The Calcutta Gazette

WEDNESDAY, JULY 6, 1921.

NOTICES TO MARINERS.

Charts affected.—No. 1026, The Solitary islands and adjacent coast.

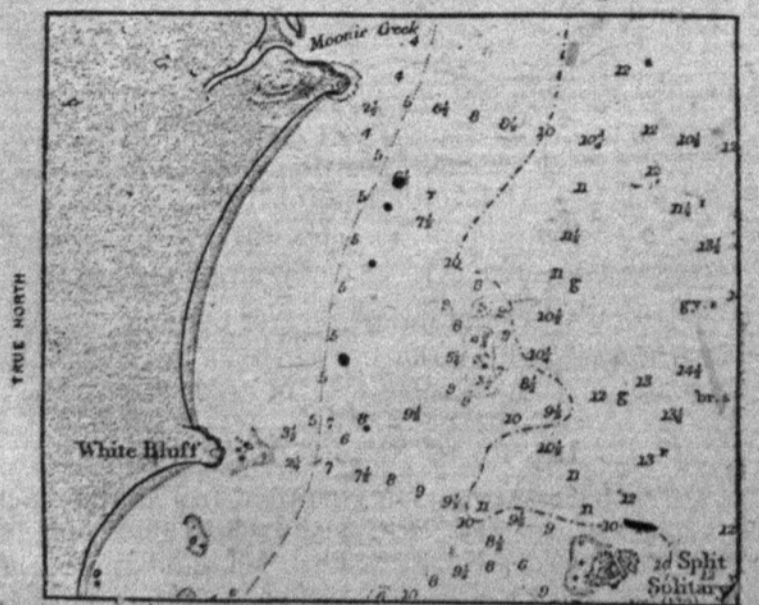
Details.—Amendments to the charts with regard to the reef north-westward of Split Solitary island, consequent upon a recent examination of the vicinity, are shown on the accompanying reproduction of a portion of chart No. 1026.

Charts affected.—No. 3401, Halsey harbour.

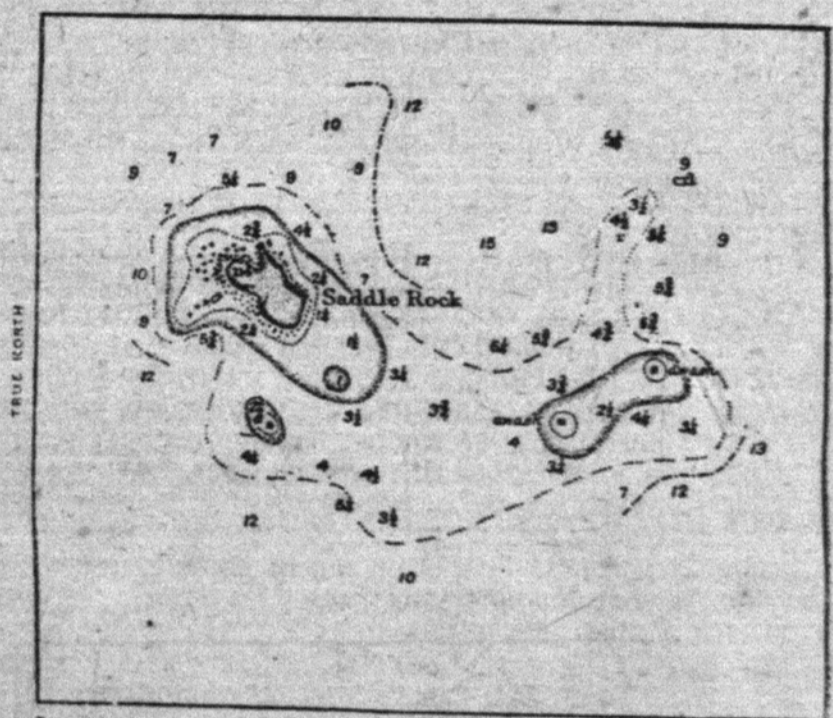
Details.—The accompanying reproduction of a portion of chart No. 3401 shows the necessary corrections to that chart with regard to the shoal eastward of Saddle rock.

Split Solitary Island—Amendments to charts with regard to reef north-westward of.

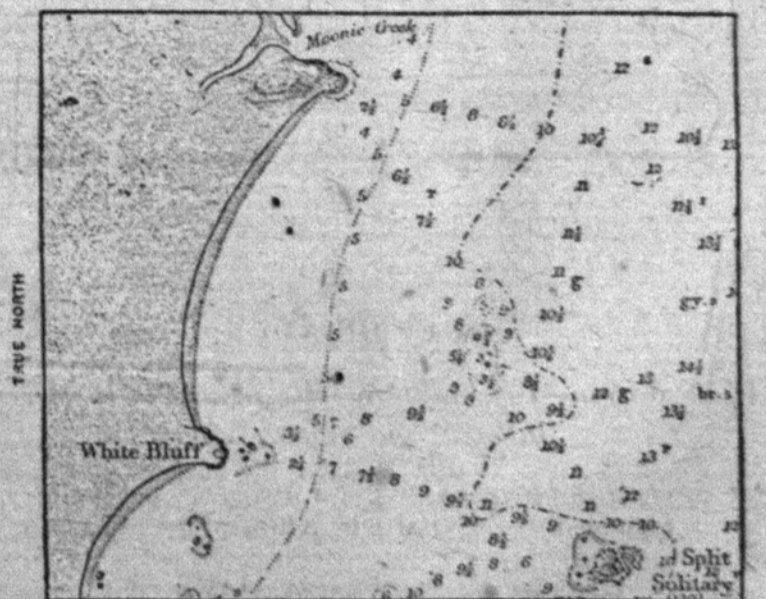
Details.—Amendments to the charts with regard to the reef north-westward of Split Solitary island, consequent upon a recent examination of the vicinity, are shown on the accompanying reproduction of a portion of chart No. 1026.

Charts affected.—No. 3401, Halsey harbour.

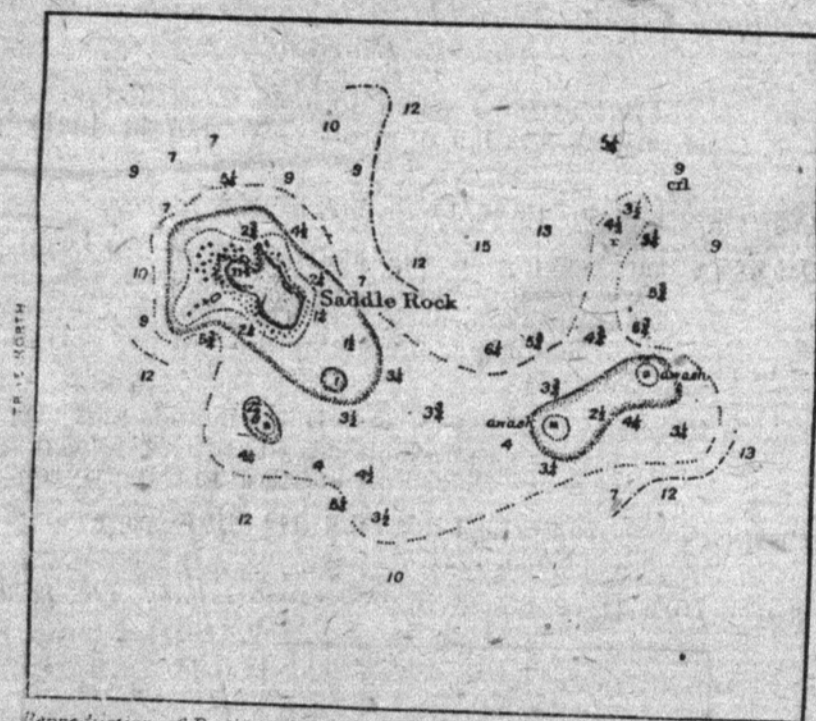
Details.—The accompanying reproduction of a portion of chart No. 3401 shows the necessary corrections to that chart with regard to the shoal eastward of Saddle rock.

Charts affected.—No. 1026, The Solitary islands and adjacent coast.

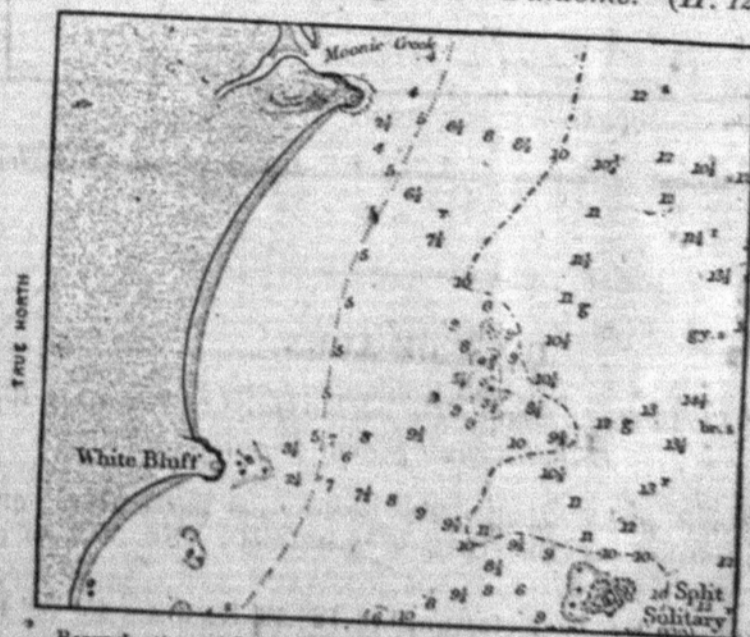
Details.—Amendments to the charts with regard to the reef north-westward of Split Solitary island, consequent upon a recent examination of the vicinity, are shown on the accompanying reproduction of a portion of chart No. 1026.

Charts affected.—No. 3401, Halsey harbour.

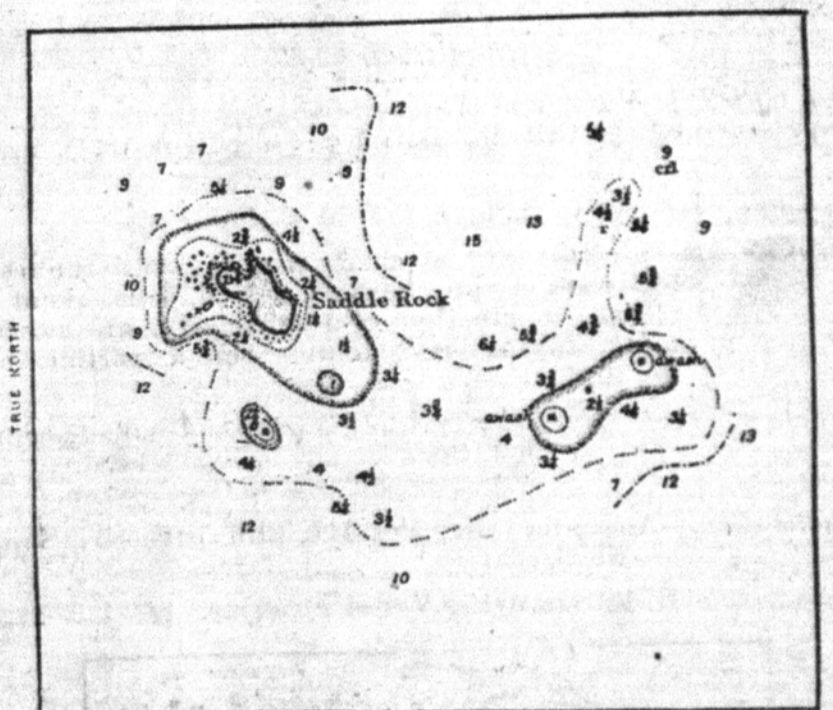
Details.—The accompanying reproduction of a portion of chart No. 3401 shows the necessary corrections to that chart with regard to the shoal eastward of Saddle rock.

Nagahama—Amendments to charts with regard to depths and shoals.

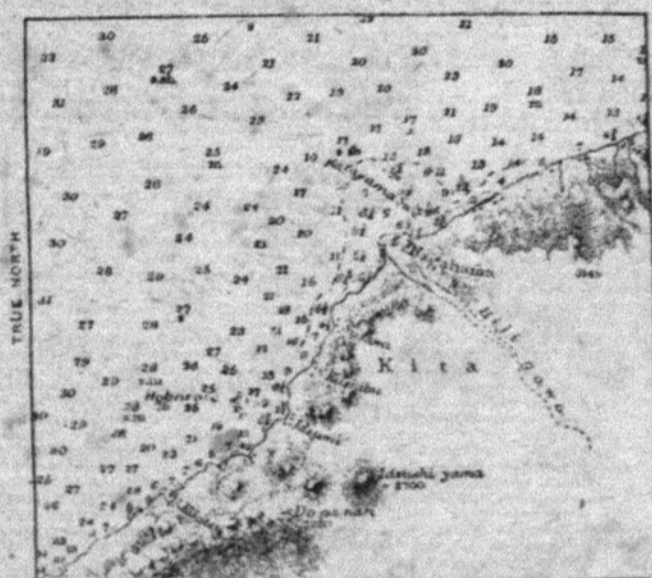
Details.—The accompanying reproduction of portions of charts Nos. 2875 and 1648 shows the necessary corrections to those charts with regard to depths, shoals and the coast line in the vicinity of Nagahama and approach.

Charts affected.—No. 3732, Penang harbour.

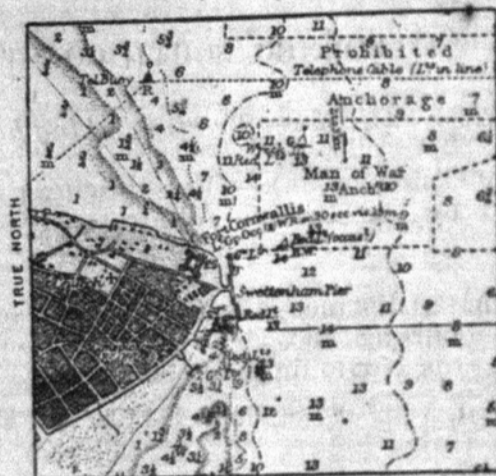
Details.—The accompanying reproduction of portions of charts Nos. 3732 and 1366 shows the necessary corrections to those charts with regard to Swettenham pier, the positions of the pier lights, and the alteration in position of the buoys in the vicinity of the pier.

Charts affected.—No. 1070, Port Stephens.

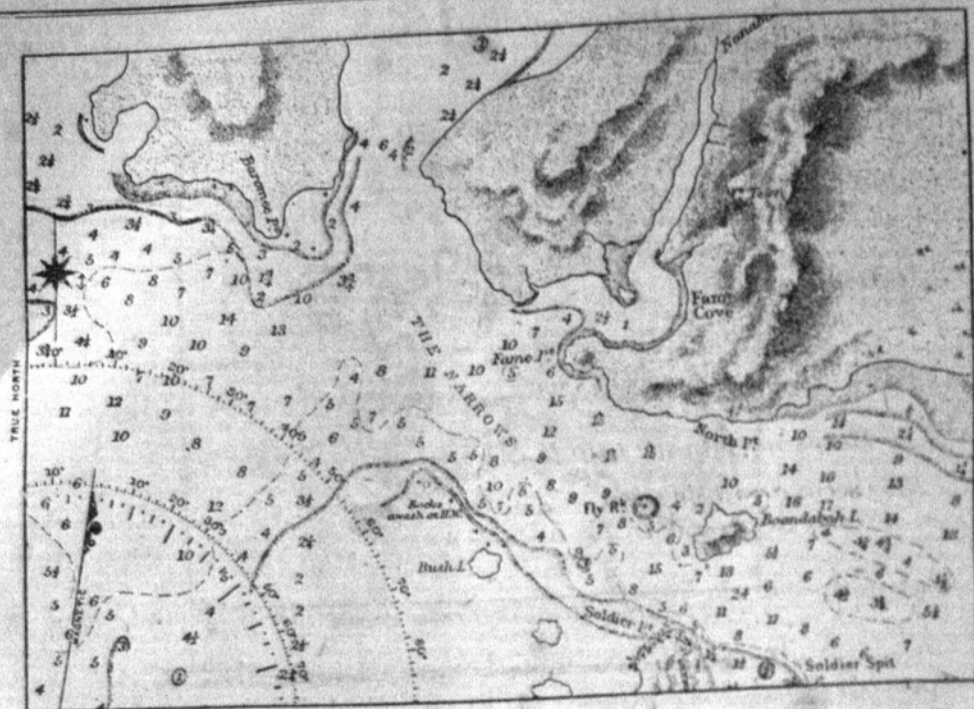
Details.—The accompanying reproductions of portions of charts Nos. 1070, 1021, 1024 and 3622 show the necessary corrections to those charts with regard to shoals, as revealed by a recent survey.

A recent survey shows the existence of a number of additional dangers outside the main channel; this chart must therefore be used with caution.

Chart affected.—No. 1999, Ports Lyttelton and Levy, and Pigeon bay, with plan.

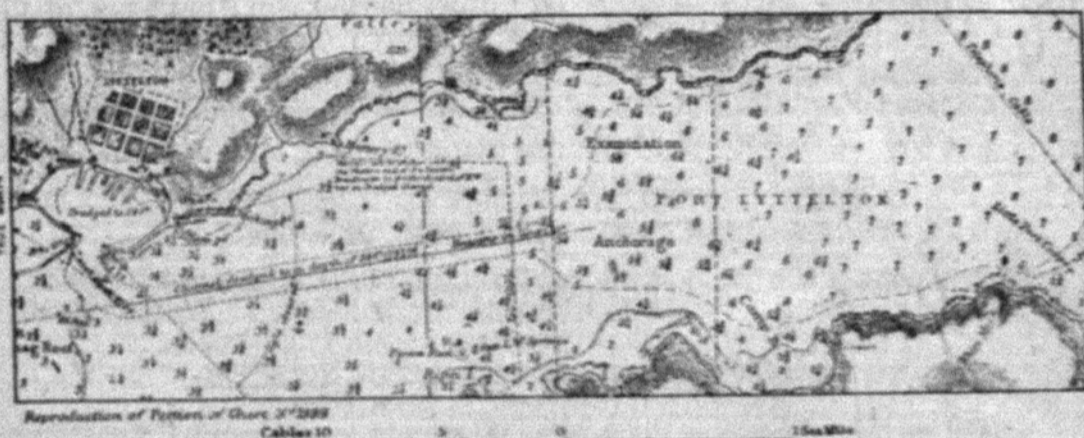
Details.—The accompanying reproductions of portions of chart No. 1999, show the necessary corrections to that chart with regard to the depths in Lyttelton harbour and the entrance channel.

Reproduction of Portion of Chart N°3720

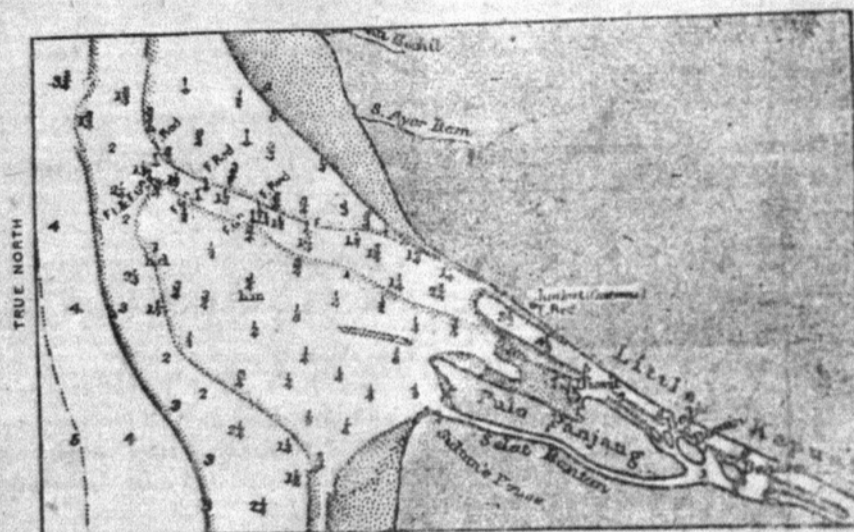
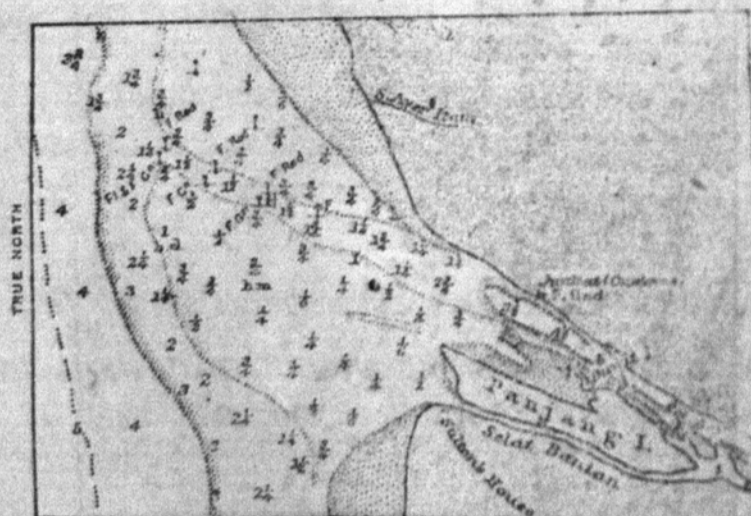
Details.—The accompanying reproduction of portions of charts Nos. 3720 and 3721 shows the necessary corrections to those charts with regard to depths, &c., in the entrance to Little Kapuas river, together with the amended position of the fixed red light at Junkat.

Charts affected.—No. 3440, Plan of Katapu anchorage.
 „ 3744, Tanjong Suabur to Kabu islands, etc.
 „ 3745, Kabu islands to Tanjong Kasbi, etc. (2).
 „ 942b, Eastern archipelago—sheet IV.

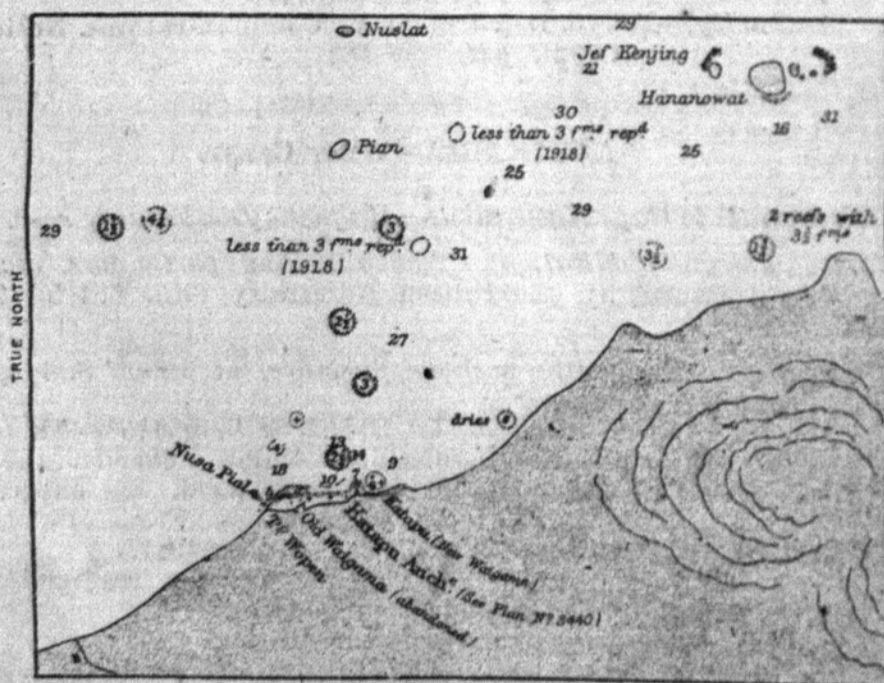
The inner $2\frac{1}{2}$ fathom shoal, which is situated at a distance of 13.05 cables, 063° , from the centre of Nusa Pial, is to be inserted on the plan of the abovementioned anchorage on chart No. 3440.

Reproduction of Portion of Chart N° 967

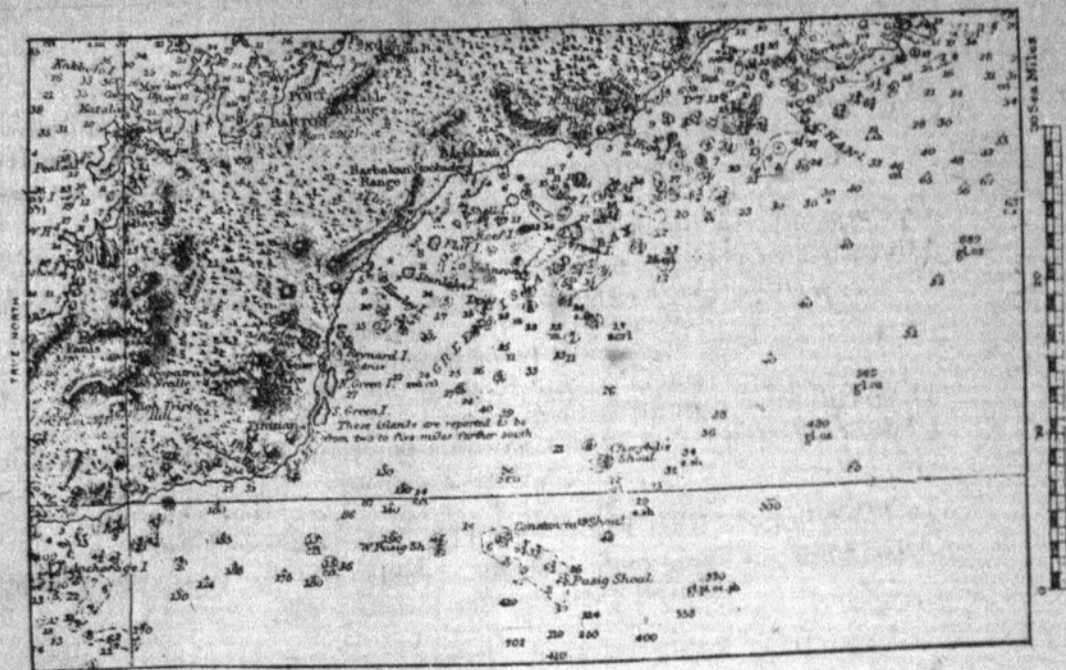
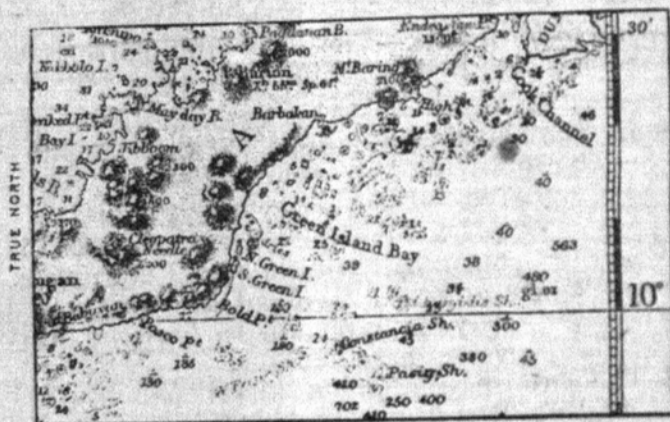
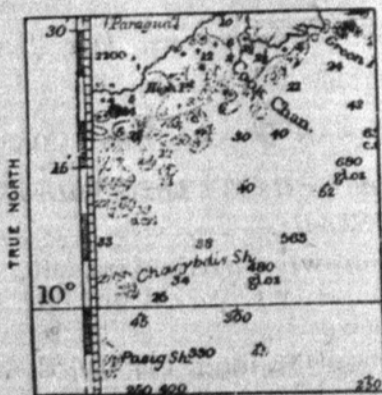
Details.—The accompanying reproductions of portions of charts Nos. 967, 2660b, 943, 2578 and 1263 show the necessary corrections to those charts with regard to reefs and shoals between Deep bay and Dumaran island.

Reproduction of Portion of plan on Chart No. 684.

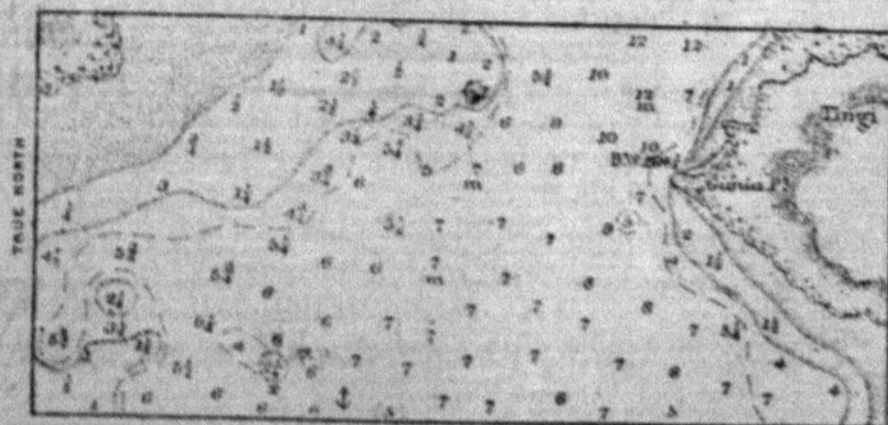
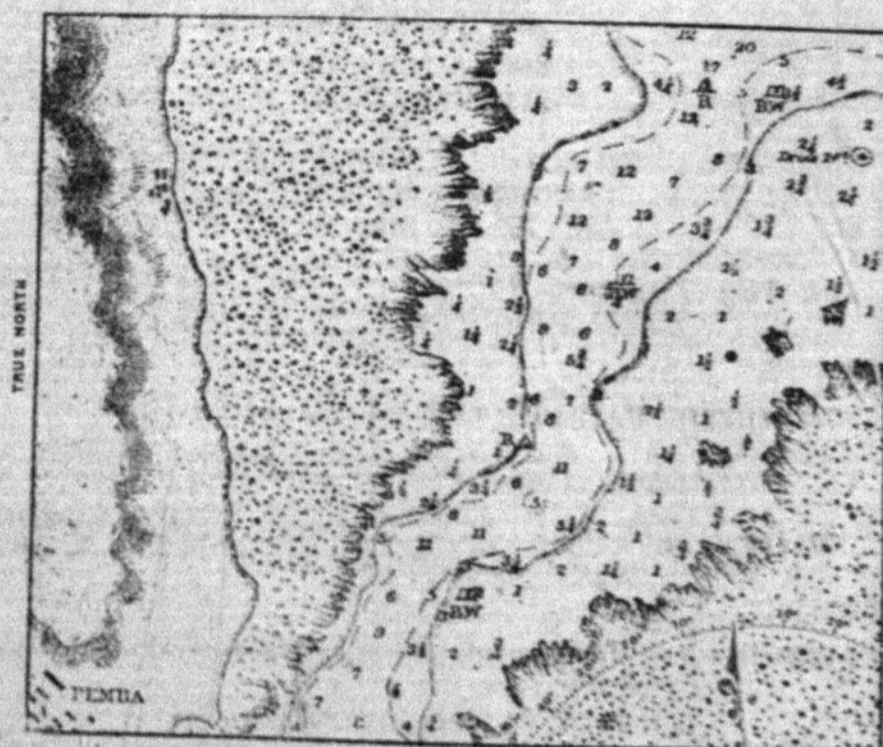
Details.—The accompanying reproduction of two portions of the plan of Mikindani harbour entrance on chart No. 684 shows the necessary corrections to that plan with regard to buoyage.

Charts affected.—No. 2265, Kobe and Hyogo bays.

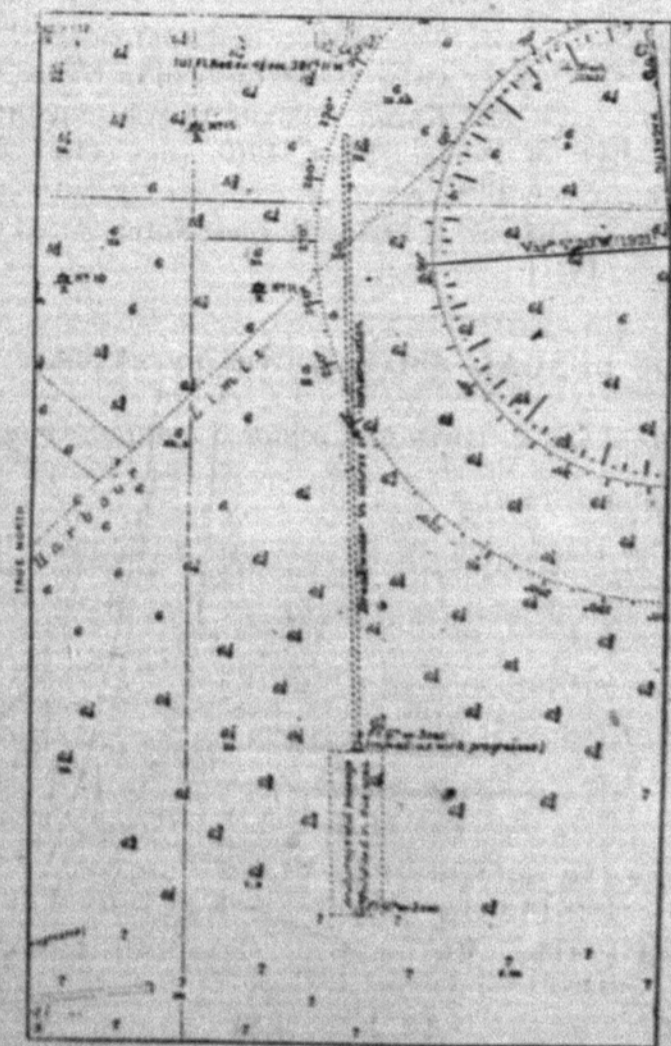
Details.—The accompanying reproduction of a portion of chart No. 2265 shows the projected limits of a detached breakwater in course of construction together with an area which is marked by light-buoys and within which anchorage and passage are prohibited; the prohibited area will be extended, and the northern light-buoy moved, as the work advances.

Akyab, Inner Bar—Amendments to chart with regard to depths.

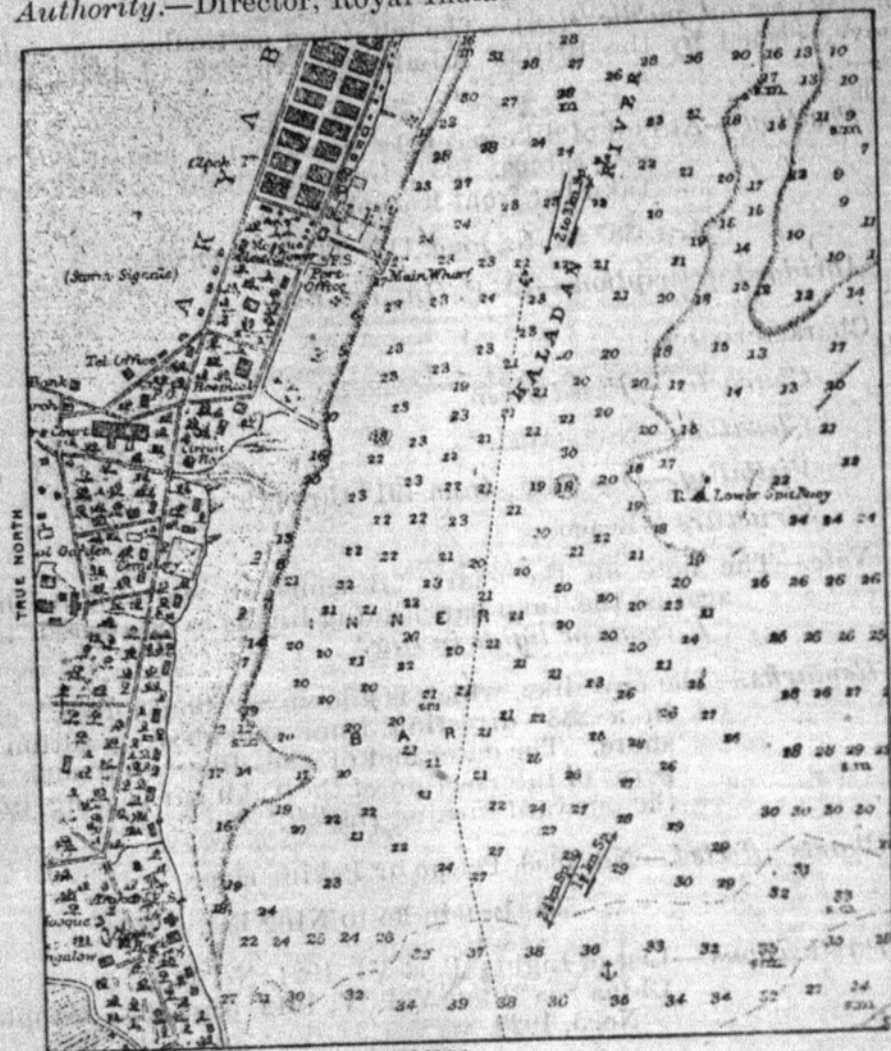
Details.—Amendments to the charts with regard to depths on the inner bar and vicinity, consequent upon a recent survey, are shown on the accompanying reproductions of portions of charts Nos. 1884 and 1369.
